TOWN OF MIDDLEBURY

REGULAR MEETING MINUTES Tuesday, February 28, 2023 7:30 P.M.

At the request of the Town of Middlebury's Conservation Commission (a.k.a., Inland Wetlands & Watercourses Agency), REMA ECOLOGICAL SERVICES ("REMA") has been asked to review the plans and other supporting documentation for an application for activities within regulated wetlands and their upland review areas (URAs), for two proposed warehouse and distribution buildings, at the above-referenced +/-112-acre site. Our review is based on the following:

**Re: Response to Third Party Technical Wetland Application Review
Southford Park – Timex Site
555 Christian Road and 764 Southford Road
Middlebury, Connecticut
SLR: #141.20970.00002**

Corrected Photo 22 (from February 16, 2022 Photolog)

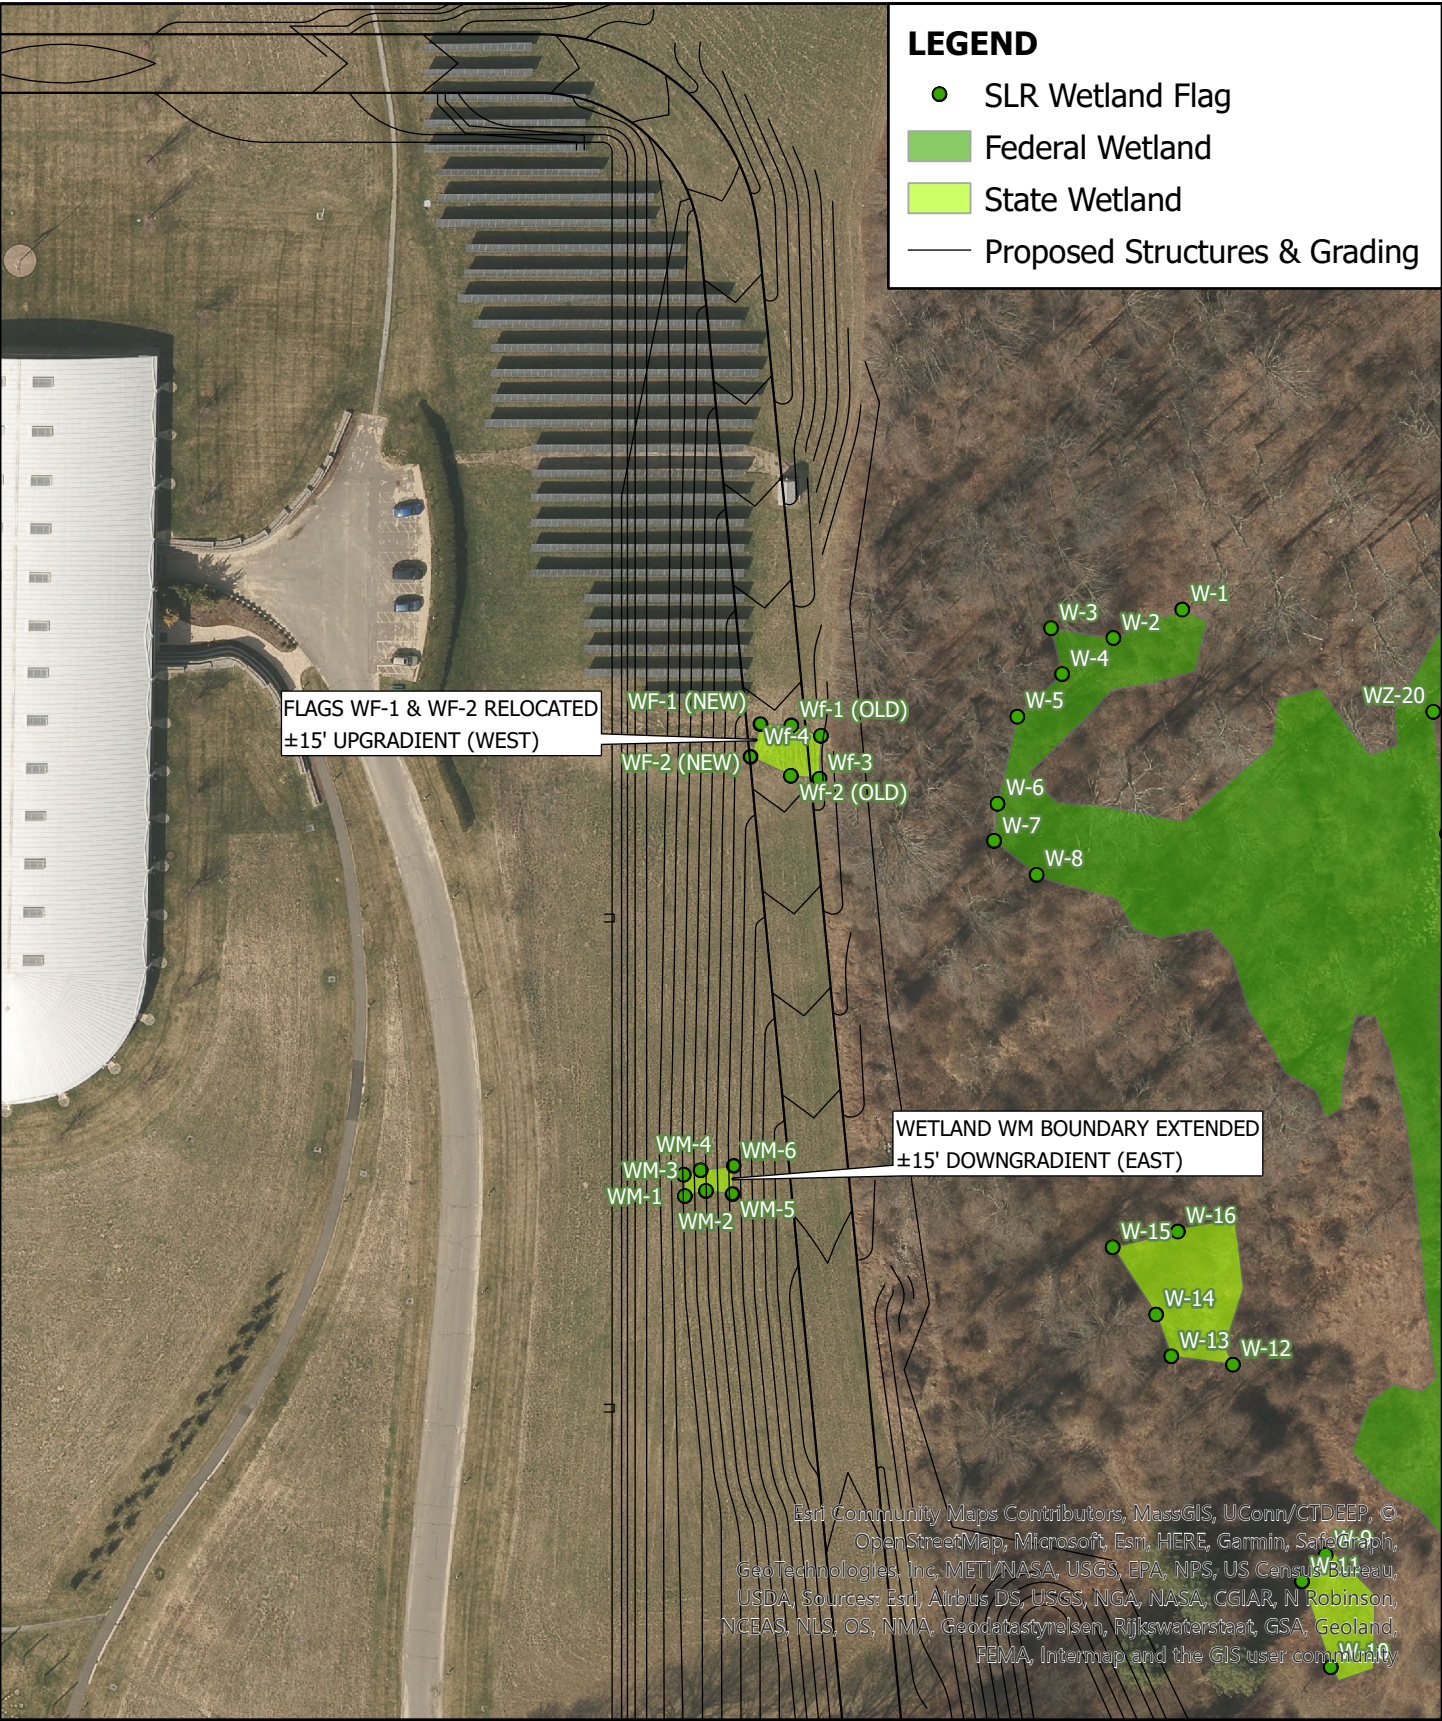
SLR International Corporation (SLR) received a third-party wetland application letter dated February 22, 2023, from the REMA Ecological Services, LLC regarding George Logan's (the proprietor of REMA) review of the project site, wetland boundaries, wetland permit application, wetland boundary verification letter prepared by SLR dated February 16, 2023, and associated project plans. As part of his review, Mr. Logan completed a followup site visit to assess the test pits and wetland boundary adjustments made in the field by SLR on February 13 and 14, 2023. Based on his follow up site visit, Mr. Logan requested that additional adjustments be made to the existing wetland boundaries at three areas and requested review of a forested slope area near Federal Wetland B.

Photo No. 22 Revised Soil Description 2-28-2023

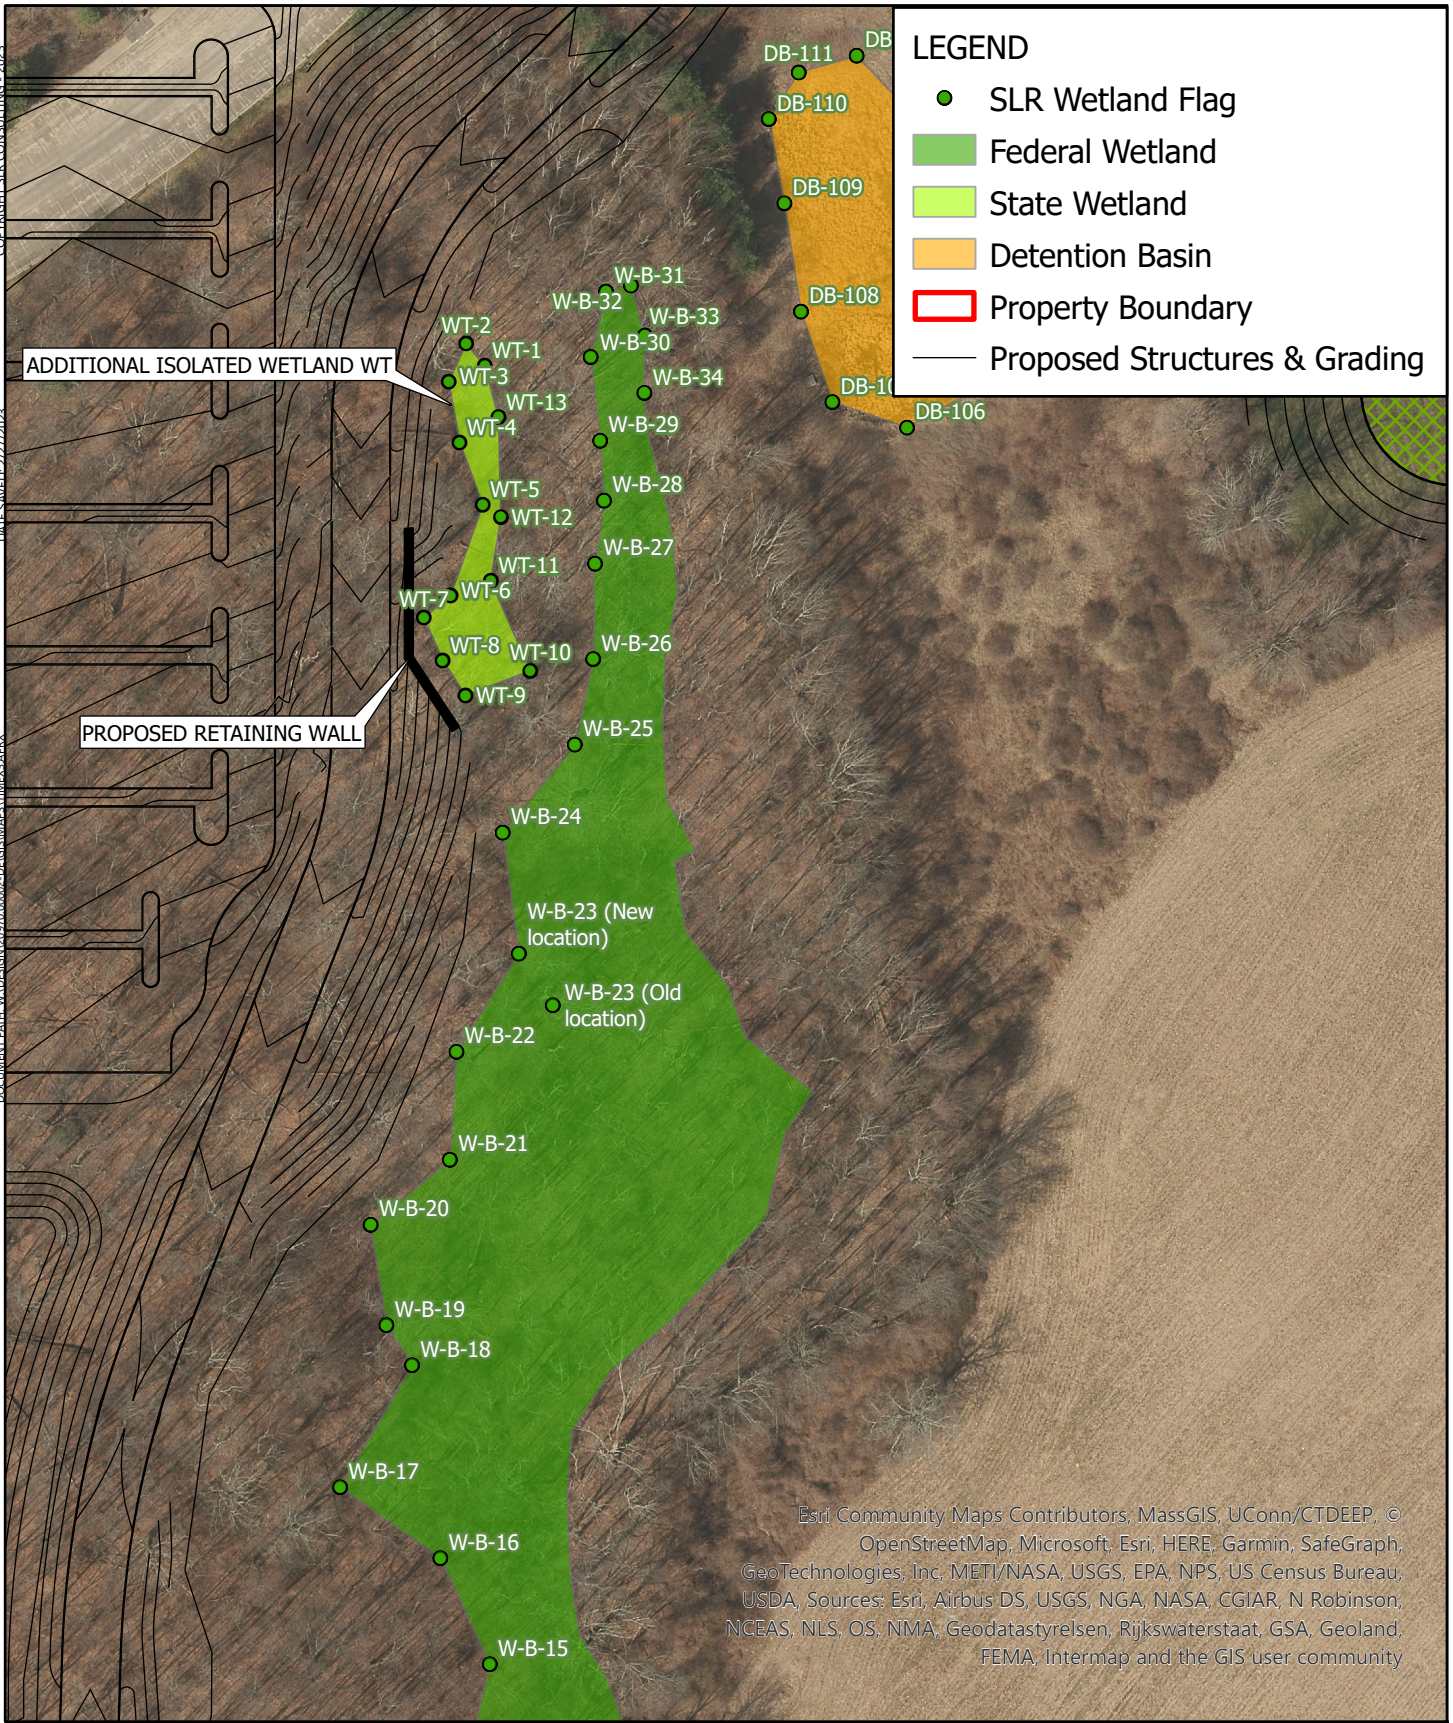
Mr. Logan requested that the farm field wetland that includes wetland flag sequences WF and WM be extended by approximately 15 feet. At wetland WF, SLR relocated flags WF-1 and WF-2 approximately 16 feet upslope from each of these flags previous locations. The new flag locations were field surveyed with a GPS unit and are shown on attached Figure 1. At Wetland WM, SLR added two additional flags, WM-5 and WM-6, approximately 15 feet downgradient from flags WM-2 and WM-4. This adjustment is noted on Figure 1. Photos of each of these wetland adjustments are provided in the attached photo log.

SLR made adjustments to existing wetland boundaries per Mr. Logan's comments and has revised these boundaries on the project site plan. Mr. Logan has additional comments within his technical review letter specifically related to existing and proposed hydrologic conditions of this site that will be addressed by the SLR civil engineering team. SLR wants to thank Mr. Logan for the expeditious and thorough review of the wetland boundaries on this site. SLR hopes that this letter provides the wetland boundary adjustments

Wetland WM added flags WM-5 and WM-6 downgradient from WM-2 and WM-4
